IN THE MATTER of Proposed Plan Change 42 Mangaroa &
Pinehaven Flood Hazard Extents

STATEMENT OF EVIDENCE OF ROBERT HALL

Flood Hazard Map 46 Vicinity of 27 Elmslie Road, Silverstream

FIG 1

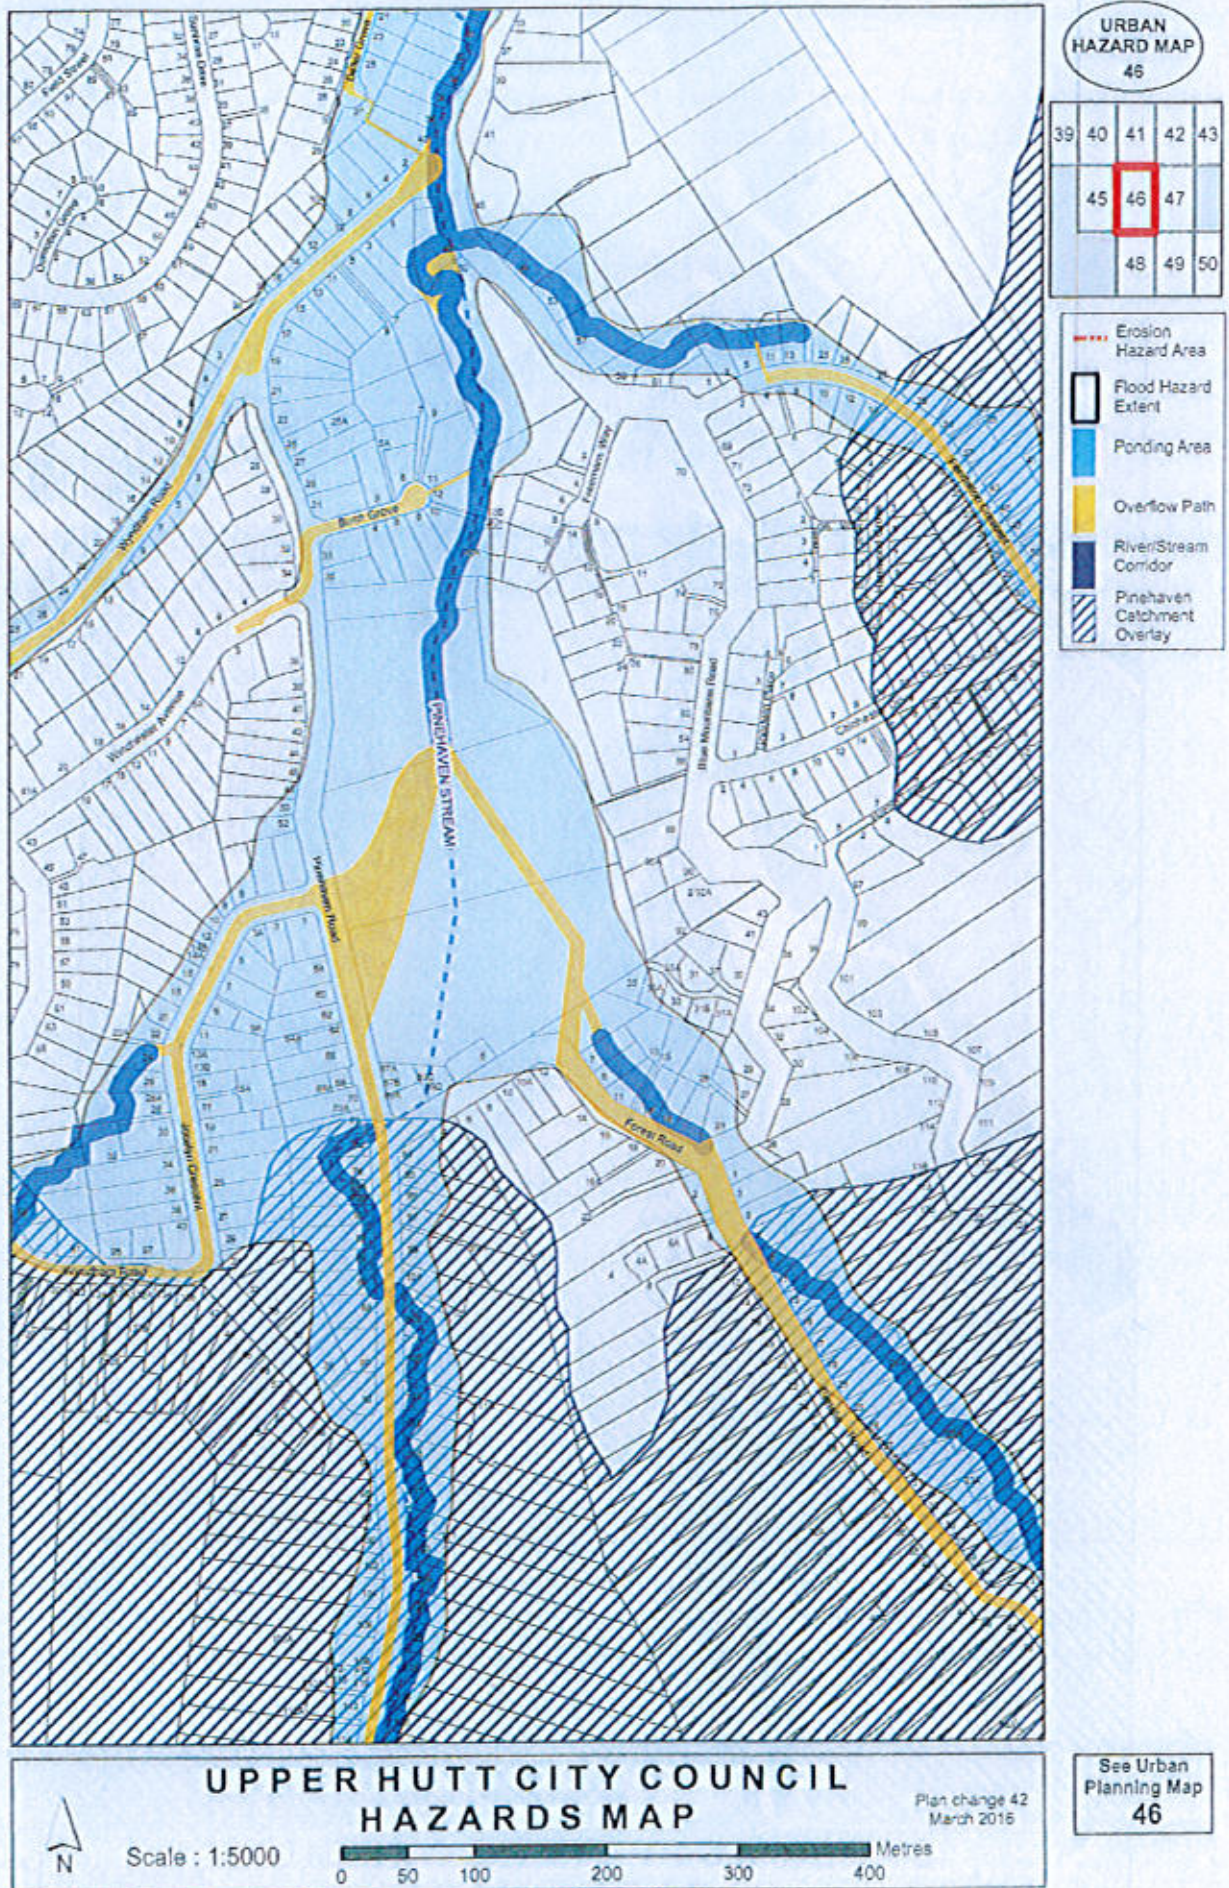
- 13 Attached Figures 1 & 2. being UHCC flood hazard map 46. Fig 1. was included in Appendix 4 of PC42 when released for public consultation. Fig 2. is the same map as Fig 1. but on which some modifications were made which affected the location of the outer limits of the " ponding areas" shown on the original Fig 1. map. As I understand it, Fig 2. was released after the consultation period closed as an appendix to the Sec 42A report for PC42 in response to a submission or submissions received through the public consultation period. I offer no opinion of the propriety or otherwise of this procedure but I note that there is nothing on

either of these maps to distinguish Fig 2 from Fig 1. other than the actual changes which were made. In my experience it is customary when preparing plans and modification are required to those plans in that process that some form of explanation and identification system is employed so that the changes which have occurred between the issues are clearly identifiable. No such system has been employed here in effect we have two plan 46's both with the same date but released at different times and with differing flood hazard zones shown on them.

- 15 When I consider the Pattinsons property at 27 Elmslie Road, I see that most of the land on the true left of Pinehaven Stream between that stream and Elmslie Road is described as a " ponding area" in a light blue shading whilst the stream proper is defined by a darker blue shading. An overflow path is shown in yellow on Elmslie Road as an overflow path and lies beyond the south western limit of the flood hazard extent. In essence I interpret this to imply that all or most of the runoff from that part of the Pinehaven catchment rising above Elmslie road in the AEP 1 / 100 year flood is captured by that road and runs down hill more or less separately and sub-parallel to the Pinehaven Stream.

- 16 There is nothing on the plan that tells me why " ponding " as such is a flood hazard, and how that area may differ from the flood hazards that might be present in the " River / Stream corridor", nor where to find that information be it in the UHCC Mangaroa / Pinehaven flood management plans or from the GWRC. It would appear that maps such as Map 46 are intended as a first step in such a process but nowhere on either Map 46 being Fig 1. or Fig 2., is that made clear.

- (b) Flood hazard maps (e.g. Urban Hazard Map 46) contained in PC 42 needs to be made informative with the addition of text to give a clearer understanding of their purpose and where more detailed information pertaining to the flood hazards associated with the flood hazard extent on the hazard maps may be found. In order to achieve that the flood hazard maps need to show the AEP 1 in 100

- (c) The term " ponding " used on the UHCC flood hazard maps are a poor choice of terminology and should be replaced with wording which more accurately describes what the nature of the flood hazards are that are identified for such areas. Having said that the maps should ensure that they limit the areas mapped as having flood hazards present, to those areas where actual flooding and related flooding effects are likely to be present and not confuse the issue by including freeboard (s) as GWRC has done and which ultimately has been adopted by UHCC to determine what their maps describe as " flood hazard extent".

FIG 3 A

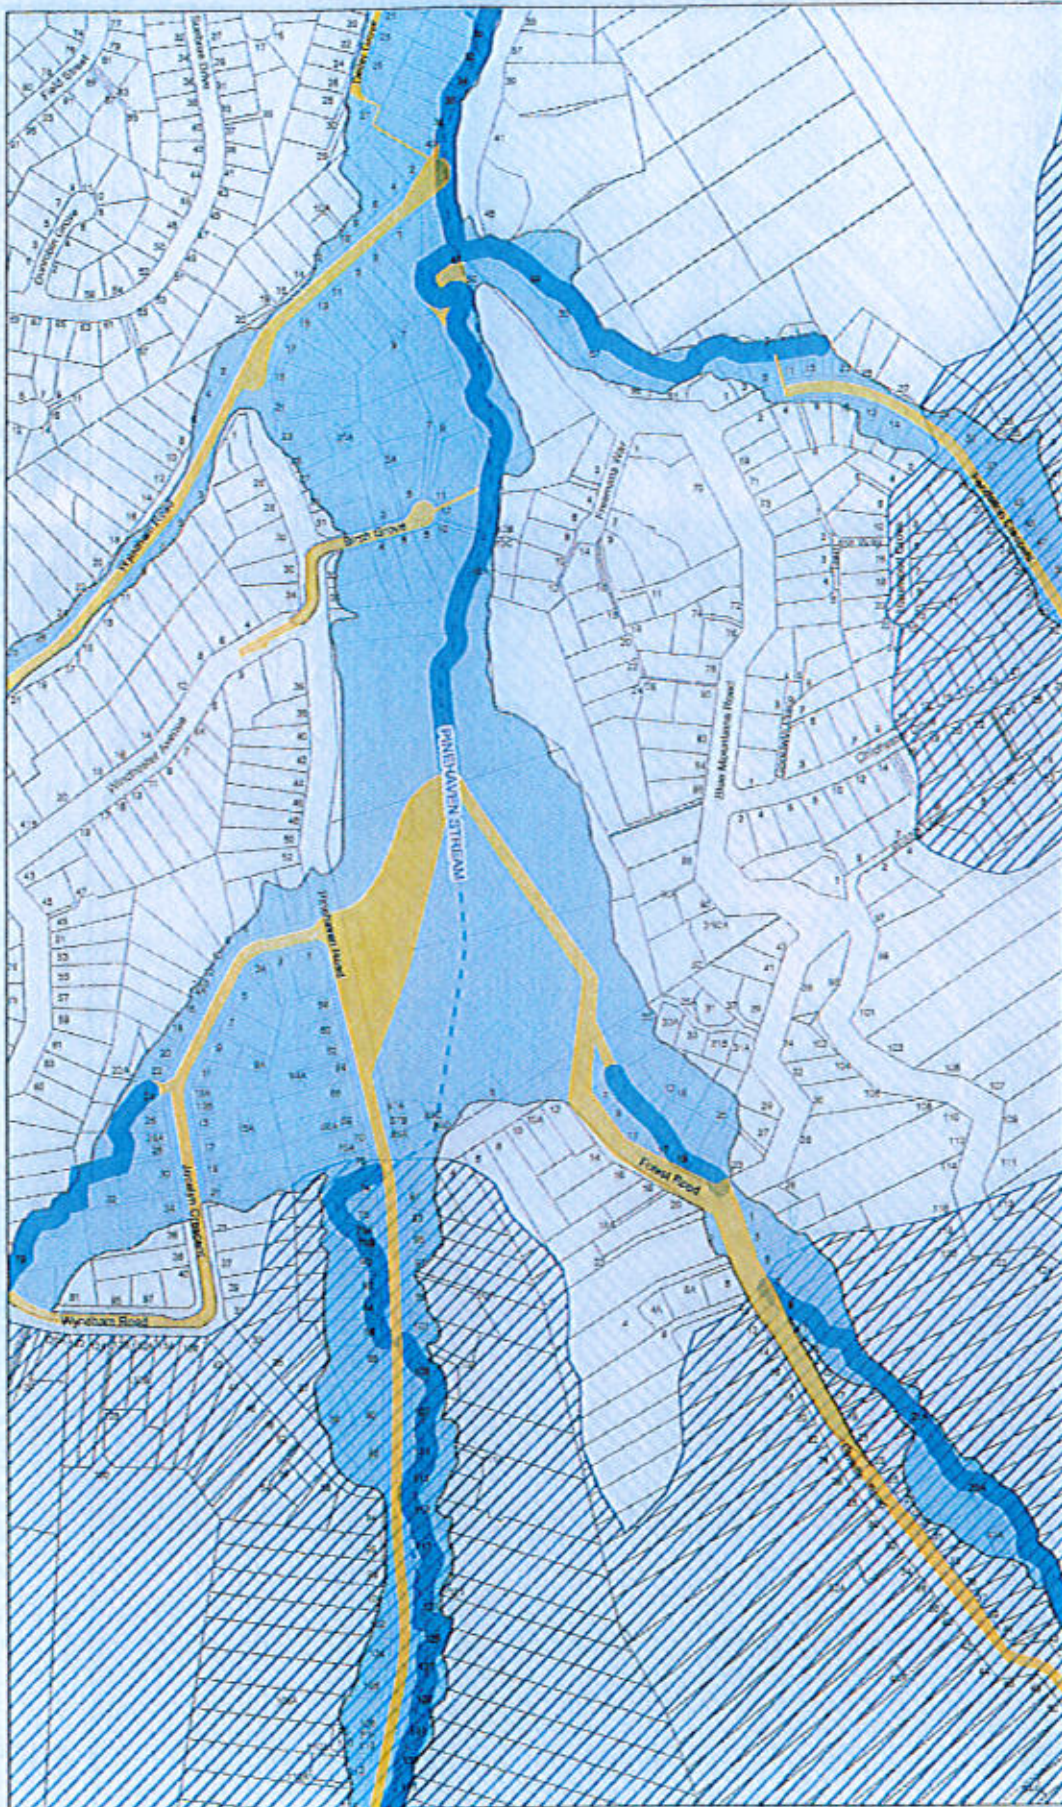
- 17 Fig's 3A & 3B. attached are Pinehaven Stream flood maps provided to a neighboring property on Elmslie Road by the GWRC at the owner of 23 – 25 Elmslie Road request in May 2017 . Fig 3A show the elevation of the flood hazard surface above ground line in metres on a grid system whilst Fig 3B gives the reduced level of that surface as opposed to the actual depth. A note on the map identifies these flood hazards as having

- 18 It is evident that these flood hazard maps extent beyond the boundary of 23 – 25 Elmslie Road and include parts of 27, 29 and 31 Elmslie Road.
- 19 The legends on Fig 3A & 3B differentiate flood hazards on the basis of depth with in particular light blue being 0.05m (i.e. presumably for depths up to 50mm), a slightly darker blue as less than 0.5m (500mm). The legend also identifies this map as representing the 100 year climate change event with freeboard and notes that the underlying 0.5m contours shown on the map are derived from a 2009 Lidar survey. These maps indicate that the Pinehaven Stream through the Pattinsons property is contained within its banks although it is difficult to determine that easily from the pixilated map format. I have carried out my own hydraulic analysis for a flow of 4.45 cumec in this reach and when my result is compared with flow depth information provided to the Pattinsons by both GWRC and M.Laws output from the GWRC hydraulic modelling it is evident that in all cases the stream flow at this level of discharge including 300 freeboard is contained with the primary channel. Fig 4 attached compares my result with the flood map produced by the GWRC for the AEP 1 / 100 flood flow with 300mm freeboard applied. There is a marked contrast in these two flood maps. This difference arises from the way the GWRC map is compiled, a 300mm freeboard is applied in both cases but their model predicts some limited shallow overland flow as well as the stream flow. When this is displayed in the manner they have used, it creates a very misleading impression of what is actually happening at the site. I will elaborate on that in Par 20 onwards. In direct contrast my map shows the actual extent of the likely flooding based on the current landform and its present use. As I will explain shortly, at present I do not think that the overland flow predicted by the GWRC hydraulic modelling will actually occur on the Pattinson property in the manner that the model predicts and accordingly the justification for mapping in the manner that they have is in my view wrong and is as a consequence creating a misleading impression of what is likely to occur in an event of this kind.

- 20 The information contained on Fig 3A. provides us with an impression of what GWRC hydraulic modelling predicts for flood depth in the AEP 1 / 100 year climate change event but it tells us nothing about the nature of the flood waters depicted on the maps other than its depth including freeboard which I understand to be 300mm although that is not stated anywhere on the map.

- 21 When I look specifically at 27 Elmslie Road on Fig 3A. the greater part of the land on the true left bank lying between Pinehaven Stream and the south western boundary of the property adjacent to Elmslie Road I see that the water depth plus 300 freeboard is with the exception of some small areas shown primarily 0.3m in depth. If there is flood water of some kind present in the areas identified with 0.3m of depth and given the intervals being used are steps of 0.1m one might conclude that the actual water depth if present at all would be in the range of 0 to 49mm assuming that the actual modelled depth excluding the 300 mm freeboard, has been either rounded up or down, in this case down. This map does not tell me what form the water has, e.g. is it "ponding" as the UHDC flood map 46 (Fig 1, Fig 2) indicate or is it moving water and if so where has that come from and what route is it following and how fast it is moving. In my experience "at a site flood hazard" is customarily determined and described on the basis of the scale of the product of the flow depth and the flow velocity. So whilst these maps are described as flood hazard maps in reality they are flood water depths maps. Having said that it is expected that the velocities associated with these depth profiles would be available from GWRC on request as it is information that is generated in the hydraulic modelling process.

23. It is fairly obvious from looking at the actual modelled water depths that can be derived from the depths shown on Fig 3A by subtracting 300mm of freeboard, that there could not possibly be 1.00 cumec of overflow on

- the land on the true left bank at 27 Elmslie Road extending up towards the road in a south westerly direction. Accordingly I conclude that A.Allan's description of the flow conditions are in fact wrong and cannot be relied upon.

28. Given the above it is difficult to see how a 300mm freeboard is necessary at all on 27 Elmslie Road in the areas on the true left bank berm area on Fig 3A where that standard has been adopted and it should be removed from both the GWRC and UHCC flood hazard map for this property from those areas.

30. Based on the assessment above I am of the opinion that for the berm area we are considering here on the true left bank of 27 Elmslie Road some clarity around the nature of the flood waters on that land in an AEP 1 / 100 year event (inc. climate change) is warranted to provide a better understanding as to what the land described on the UHCC flood hazard maps as " ponding " means because ponding per se is not accurate description of what is likely to be occurring on that land and accordingly creates a misleading impression.

#27 GWRC - Q100 CC 100-year Flood Map for 27 Elmslie Road, Pinehaven (September 2017) 1:200

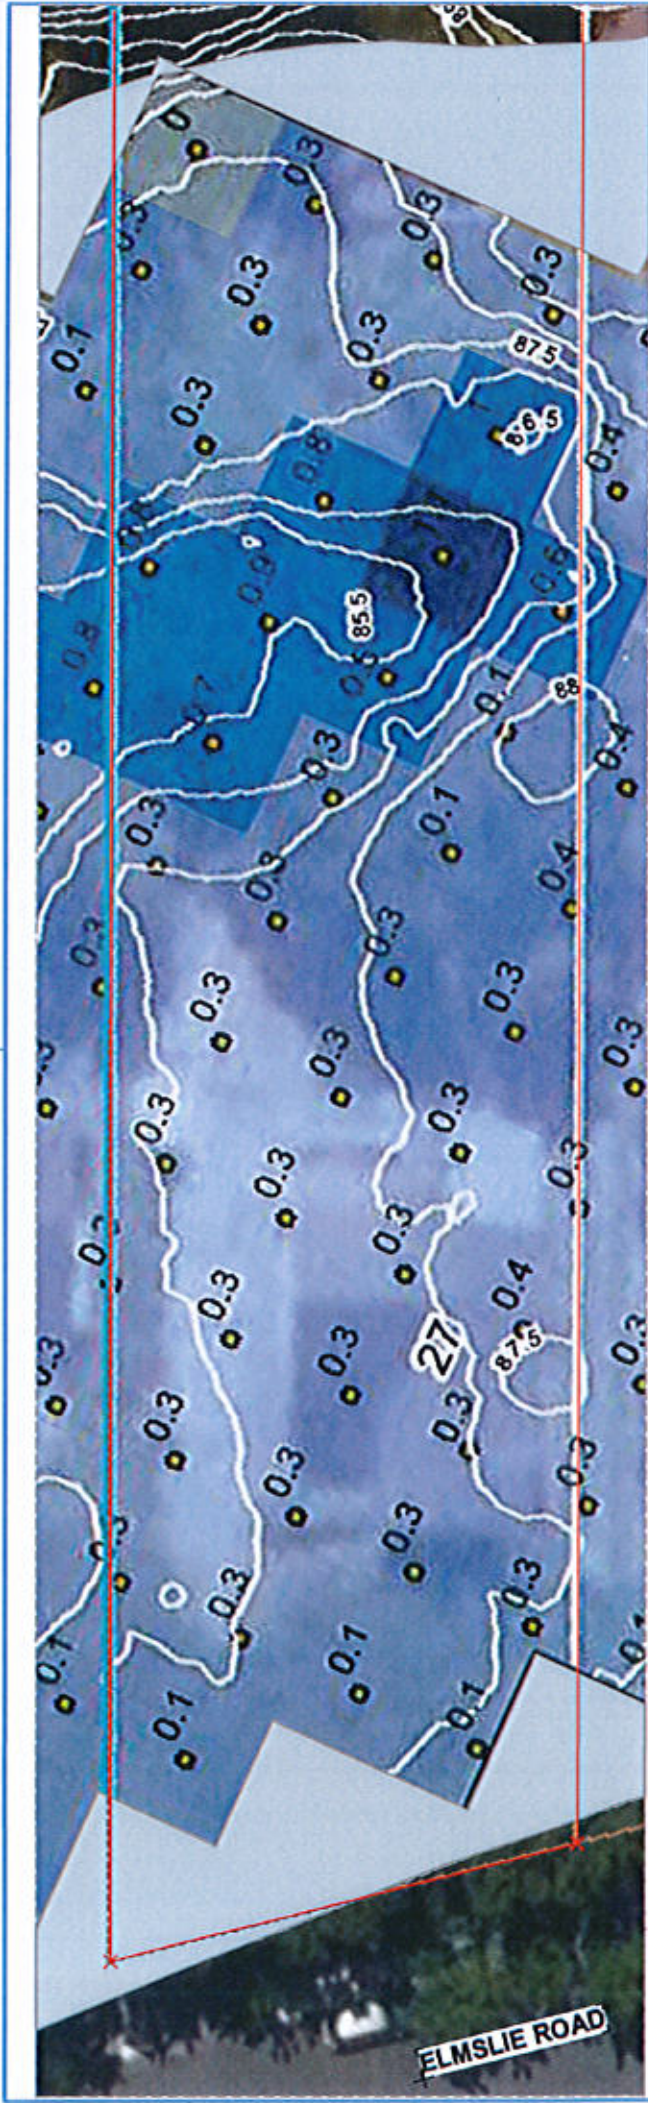
26. Both Fig 1.and Fig 2 and Fig 3A and Fig 3B clearly don't indicate that the land lying to the north east of Elmslie Road and 27 Elmslie Road have flood waters either ponding or flowing over it which would exclude Elmslie Road as a possible source of any water in the order of 49mm or less on the area shown on Fig 3A with a depth including 300mm freeboard of 0.3m. Given that situation the water that is anticipated on that land in an AEP 1 / 100 year event which includes climate change must be shallow overland flow of the type described in Par 25. above.

27. I estimate using HIRDS V3 and the Rational Method that the depth of this type of overland flow would be typically in the order of 10 to 13 litres per second (0.010 – 0.013 cumec) with a flow depth in the order of 11 to 13 mm where it flows down the driveway adjacent to the house and with velocities in the order of 0.2m/s. This result is in the same order of water depths determined in Par 26 above albeit a lot smaller. By no stretch of the imagination could we describe these conditions as hazardous, traditionally we accept them as a nuisance and the NZ Building Code accommodates such conditions by specifying a minimum floor level e.g. NZS3604 Sec 7.5.2.1 (b) (i) & (ii), slab on ground construction, unprotected by permanent paving 150mm elevation (masonry veneer wall), 225mm elevation (other exterior claddings).
